Project: <u>Central Wastewater Treatment Plant</u>	Project Number: _____
Owner: <u>City of Pflugerville</u>	<u>88</u>
Contractor: <u>BAR Constructors, Inc</u>	<u>279</u>
Engineer: <u>Freese and Nichols, Inc</u>	<u>PFL16607</u>
Change Proposal No.: <u>CP0003</u> Description: <u>Structural Support Changes</u>	
Specification: <u>05 53 00 Metal Gratings</u>

Re: City of Pflugerville, Texas
Central WWTP Expansion Phase I Improvements
Project No. PFL16607
CP003r1 Cody Builders – Embeds Material Change

CHANGE ORDER

This change order request includes change of aluminum support beams at S-AS-6, S-AS13, additional aluminum support beams at S-HW-11 per RFI009 and cable trench embeds material change from galvanized to aluminum per submittal response.

Partial Plan - Headworks Screening Facility Embed Angle Layout

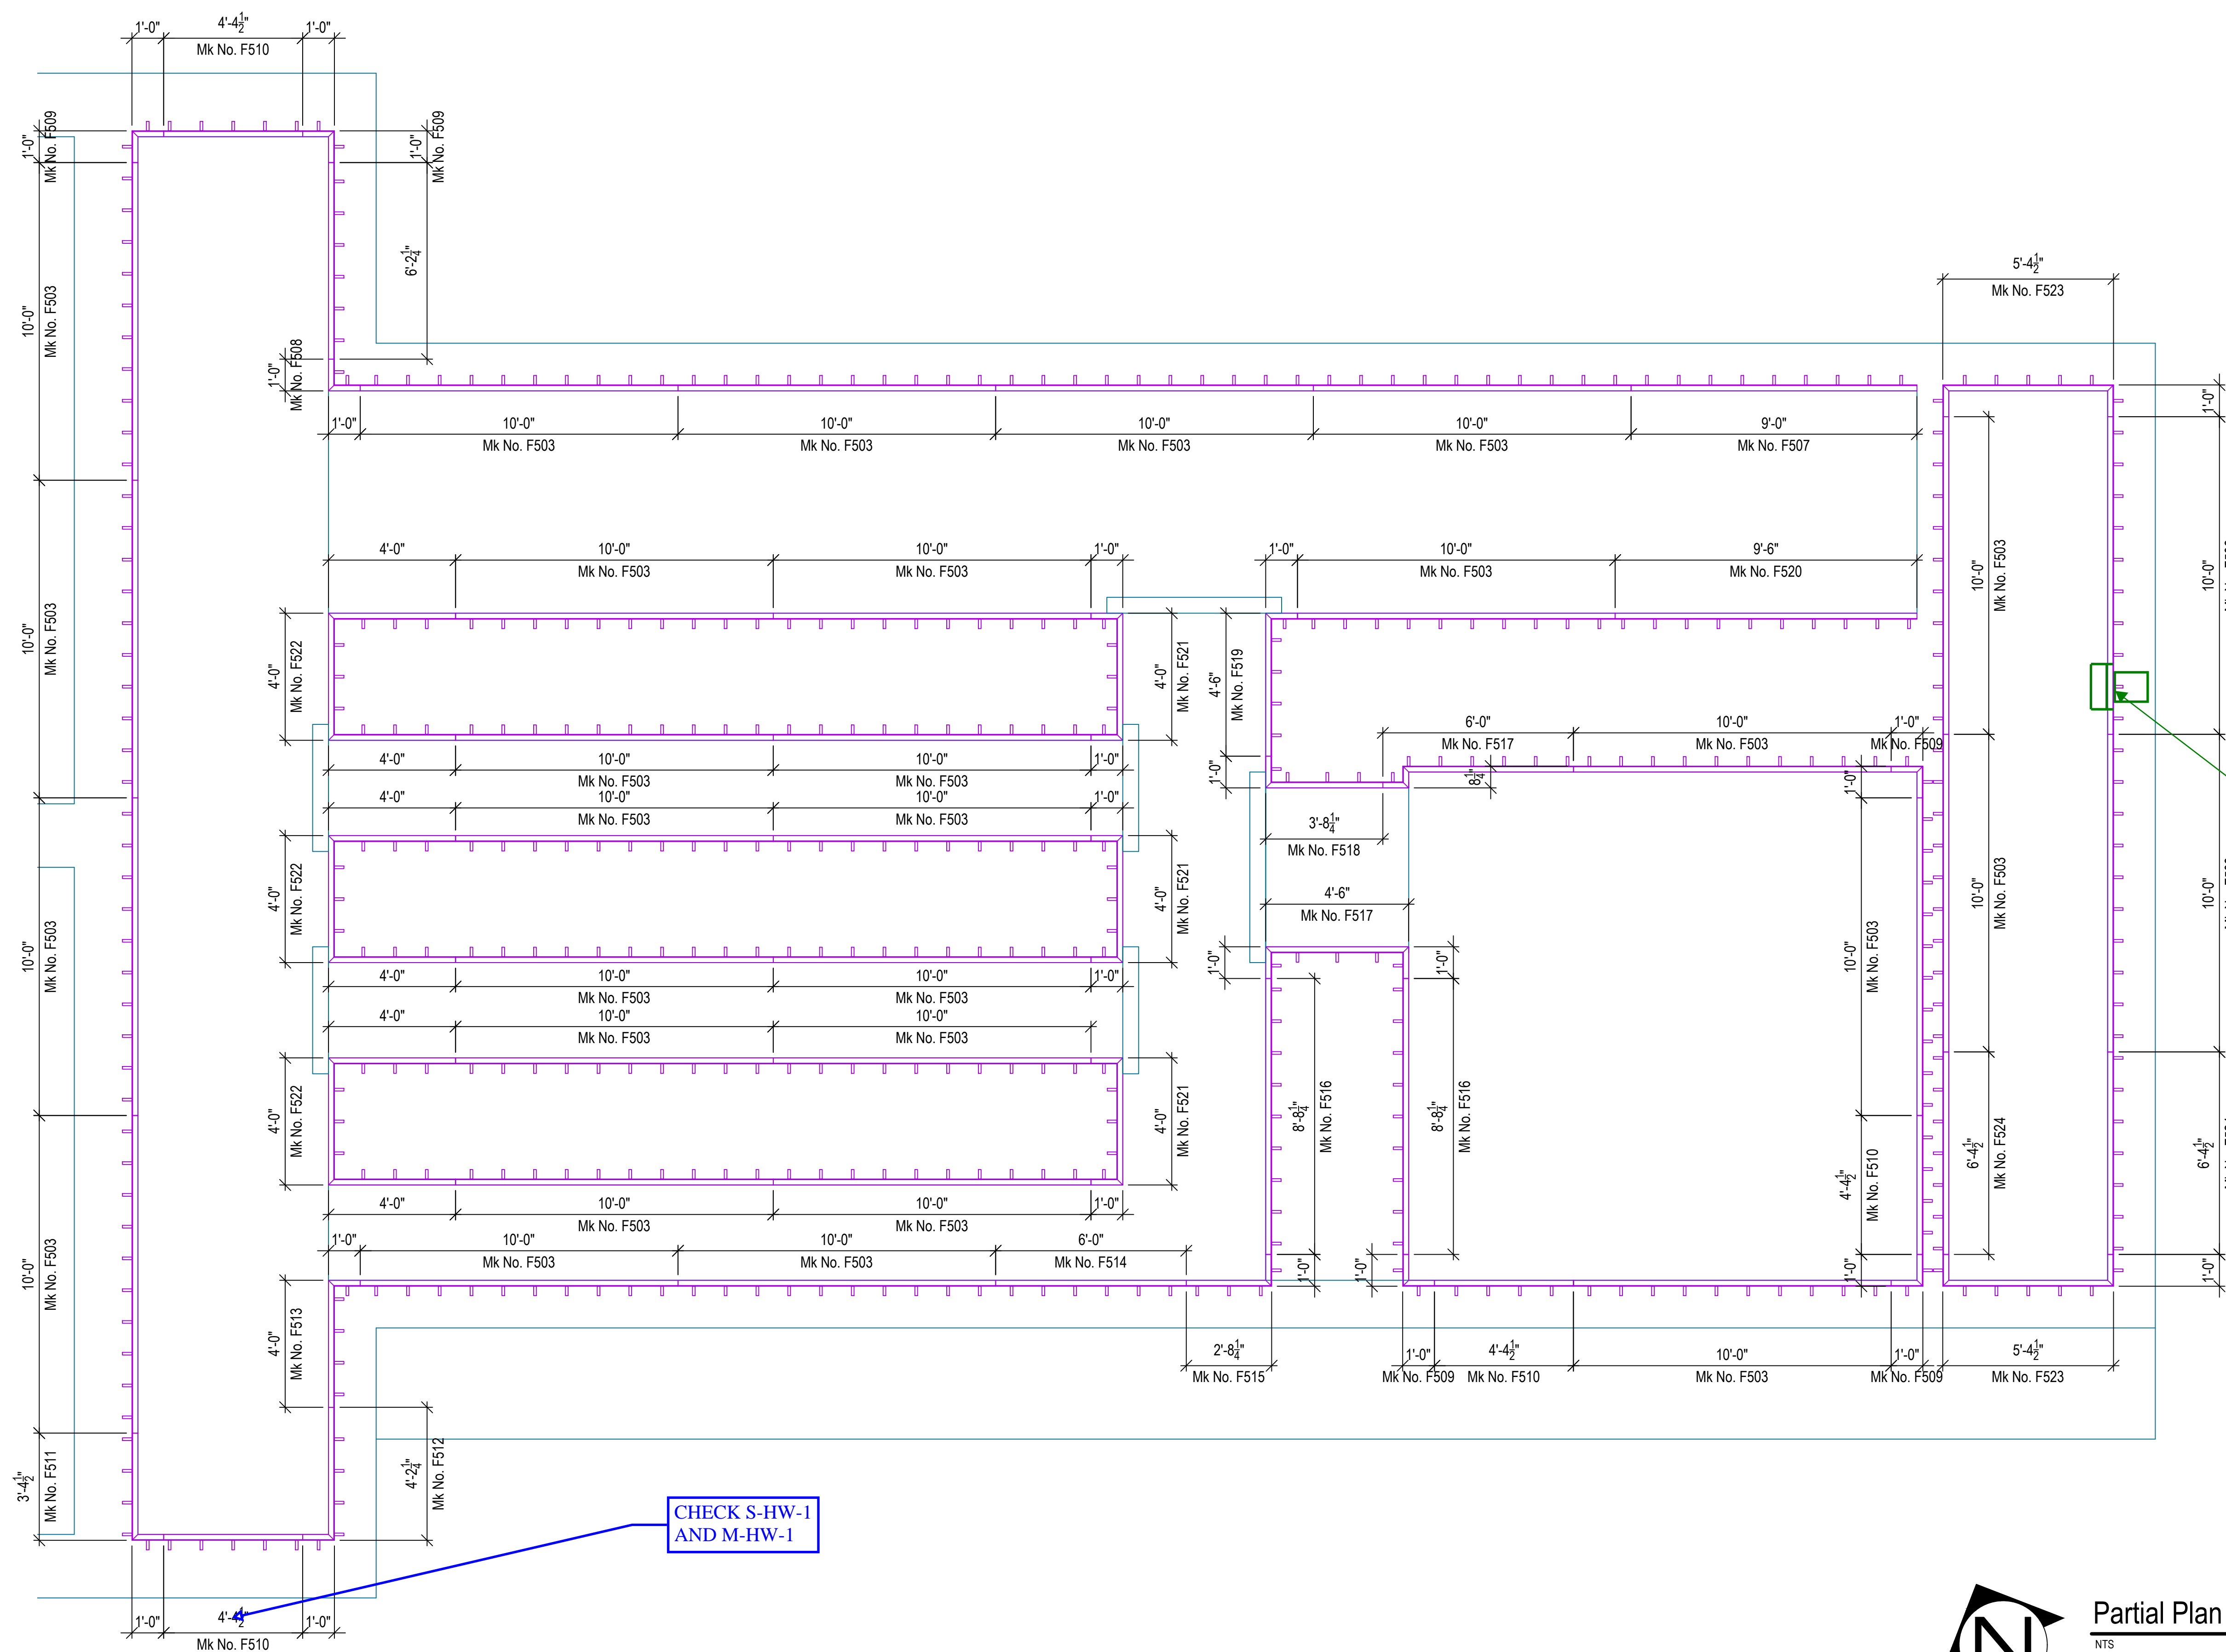
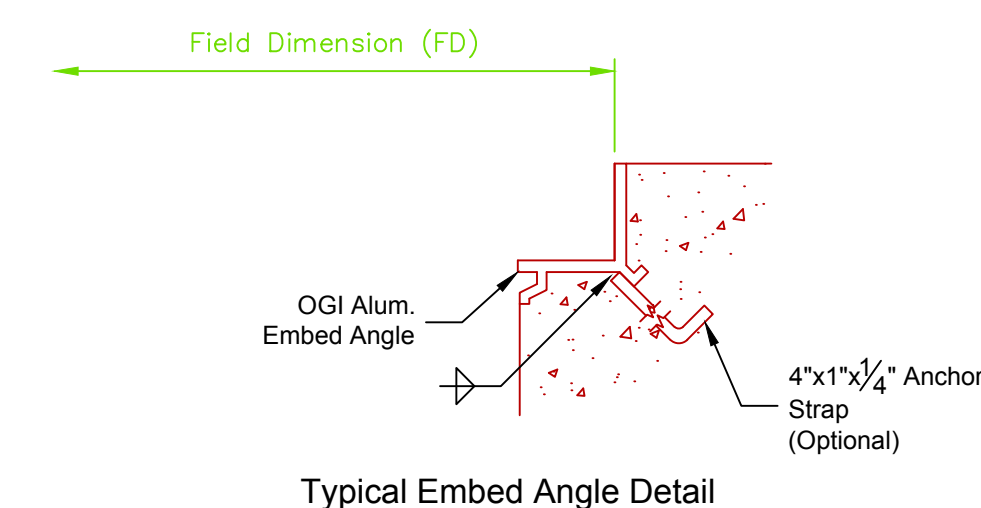
THERE IS A CONFLICT WITH THE GRATING SUPPORT EMBED ANGLE AND THE COLUMN BASE PLATE AT THIS LOCATION. STOP THE EMBED ANGLE A MINIMUM OF 2" FROM EACH SIDE OF THE COLUMN BASE PLATE. INSTALL AN ALUMINUM L5x3x1/4" LLV TO THE FACE OF THE CONCRETE WALL WITH 5/8" SS 316 ADHESIVE ANCHORS @ 12" C/C WITH 5-5/8" EMBEDMENT (7/SD-27).

CHECK S-HW-1 AND M-HW-1

OPTION 1: USE EXISTING MANHOLE 12 AS TEMPORARY LIFT STATION

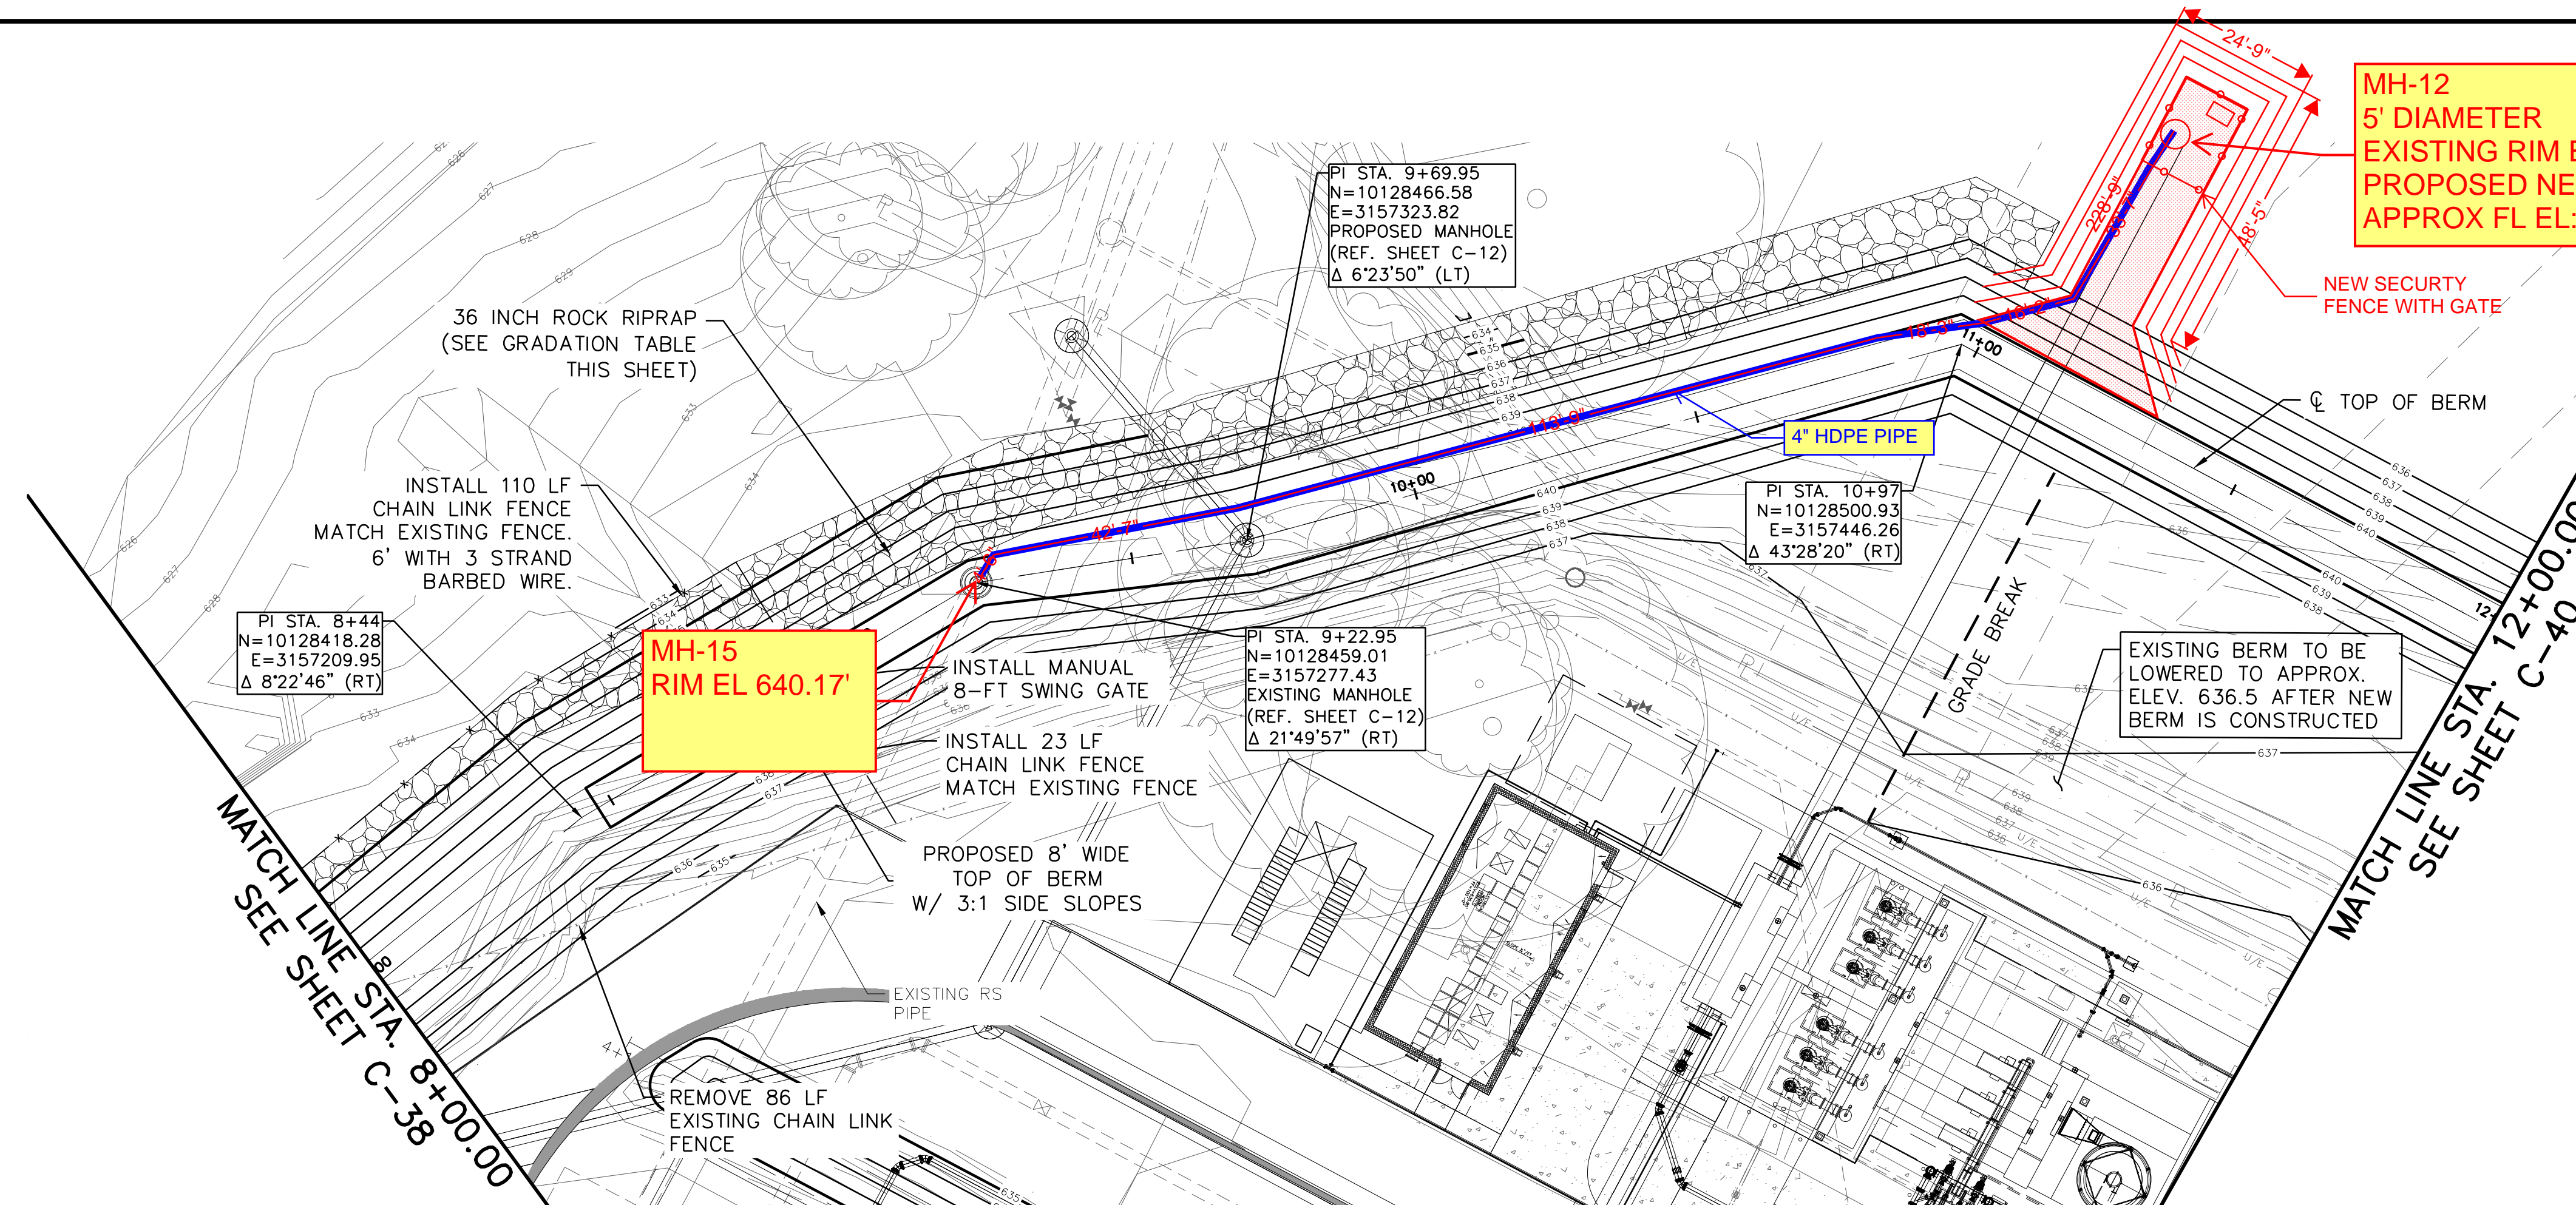
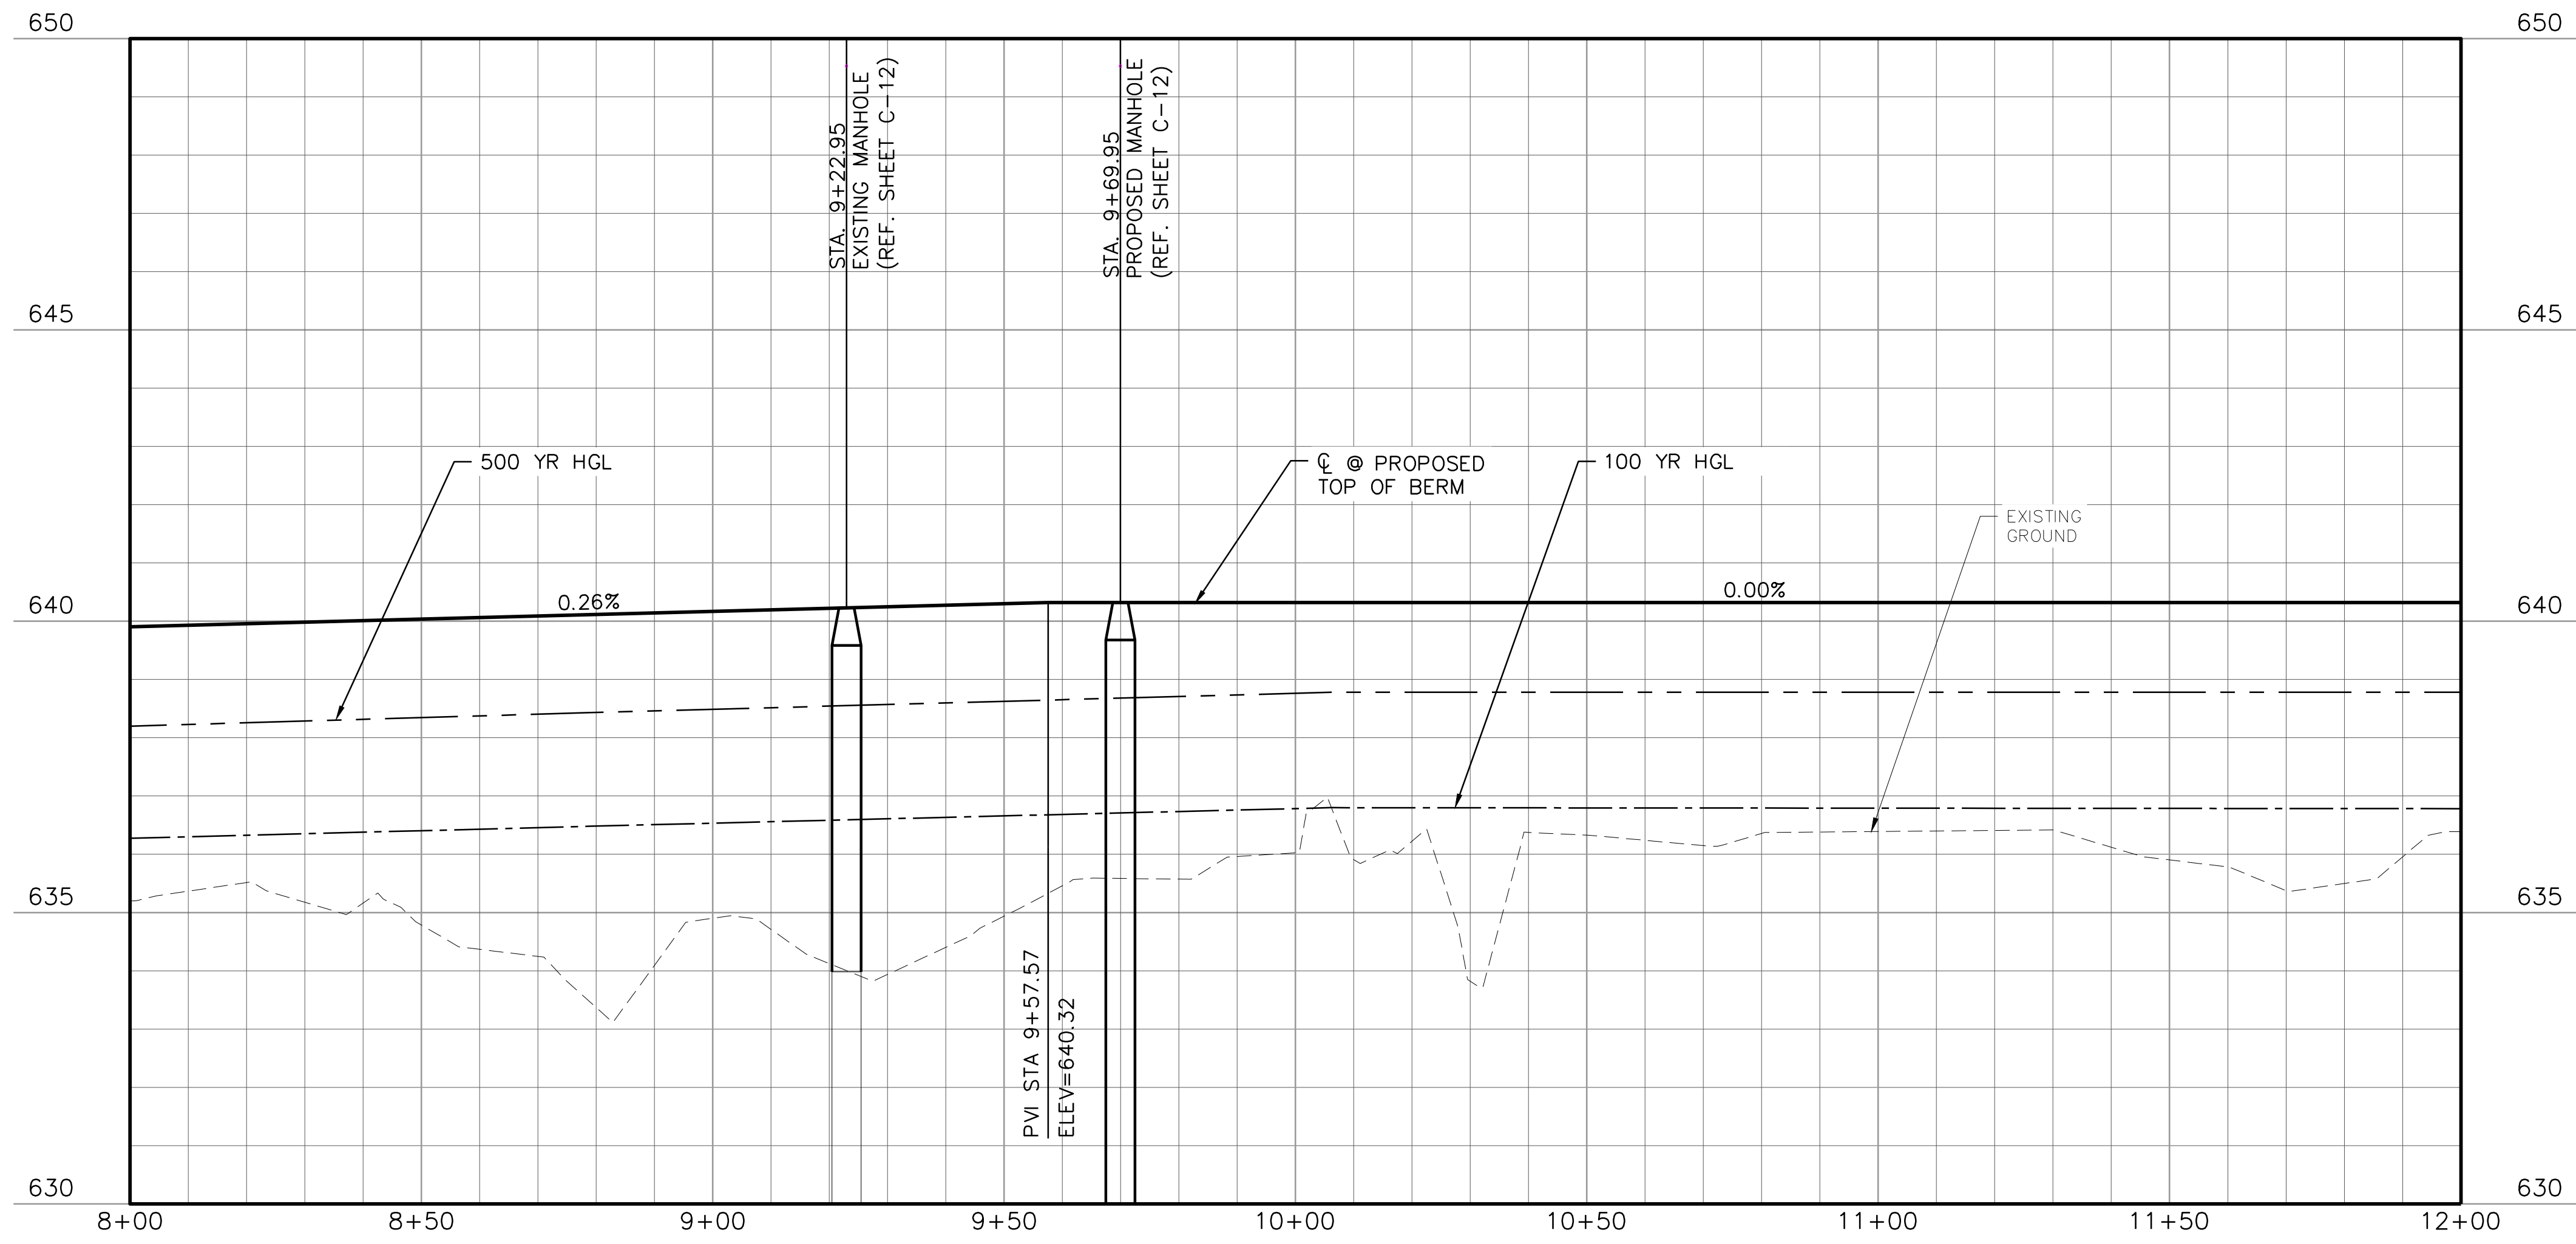
- SCOPE OF WORK:**
1. INSTALL 4.5' RISER ON EXISTING MANHOLE 12 AND PLUG OUTLET
 2. INSTALL TEMPORARY SUBMERSIBLE NON-CLOG OR GRINDER PUMP, 4" HDPE DISCHARGE PIPE, AND APPURTENANCES.
 3. EXTEND 480V ELECTRICAL FEED TO PUMP PANEL (NEW ONCOR LINES OR DIRECT BURY FROM ADMIN BLDG)
 4. EXTEND BERM AROUND MANHOLE FOR ACCESS
 5. ALTERMAN TO INSTALL RADIO CONNECTION TO PLANT SCADA FOR ALARMS
